**Re: Addendum - inventory eroding mercury mining wastes - response & map now due
July 13, 2011; Guadalupe Rubbish Disposal Company, San Jose California.**

SUBJECT: ADDENDUM TO DECEMBER 23, 2010 TECHNICAL REPORT:
EVALUATION OF MINING WASTE ERODIBILITY, UNNAMED PROSPECT
RESPONSE AND MAP DUE JULY 1, 2011

Re: Responding to California Regional Water Quality Control Board Letter of 20 June 2011
Concerning 15999 Guadalupe Mines Road, San Jose, Santa Clara County.

Map 3. A 1917 view of the study area showing the remaining buildings and areas that were currently mined. Mining symbol to east (left) of eastern boundary marked the nearby Senator Mine, a part of New Almaden Mines (USGS 1917). right

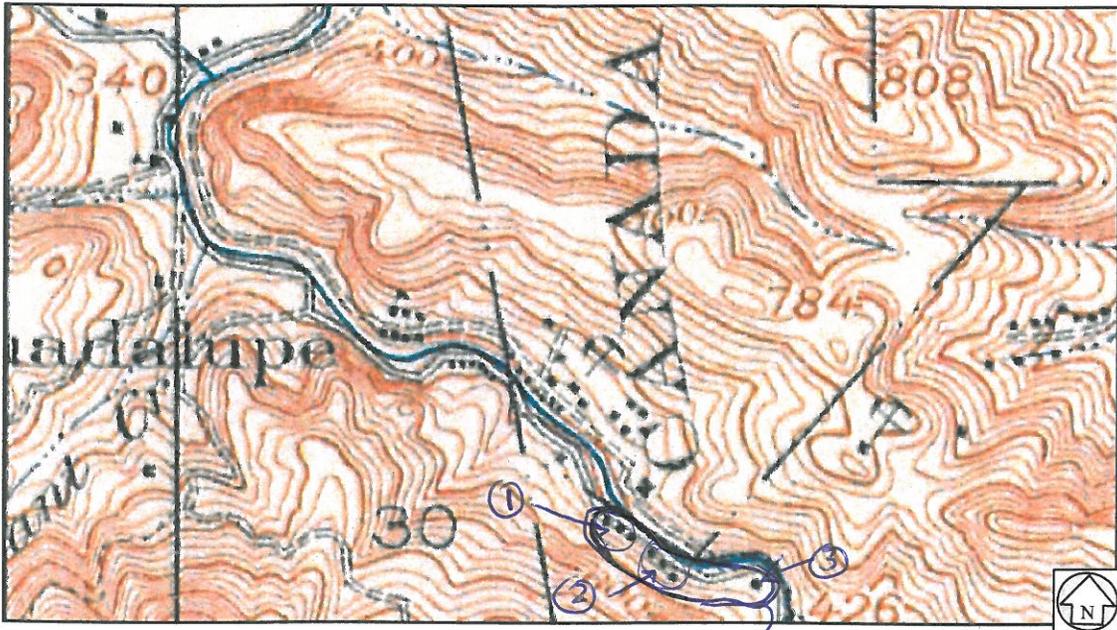
Question 2. Summary p. 34: Where on Map 3 were the three additional locations to the south?

Map 3 is a 1917 view of the general study area. Two clusters of six buildings or structures, and to the southeast, a single structure are all situated south of Guadalupe Creek and Hicks Road. These are the three locations that are marked on Map 4 as ". . . beyond the study area" and south of the gray line marking the study area boundary of Guadalupe Creek.

→ the three locations marked on Map 4 as "...beyond the study area." They are off property, south of Guad. Ck.
